Technical Service Information Bulletin April 16, 2007

### Title: BRAKE HOLD SYSTEM DOES NOT RELEASE UPON ACCELERATION Models:

'07 LS 460/460L

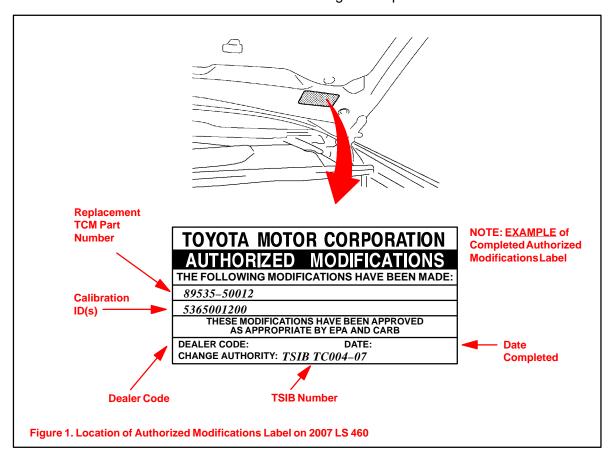
**Repair Procedure** 1. Check for the Authorized Modifications Label affixed to the vehicle in the location shown in Figure 1. Confirm if the TCM calibration has been updated. If the calibration ID listed is NOT the latest TCM calibration — go to step 2.

Repair<br/>Procedure<br/>(Continued)B. Affix the Authorized Modifications Label to the vehicle at the location shown in<br/>Figure 1. The Authorized Modifications Label is available through the MDC,<br/>P/N 00451–00001–LBL.
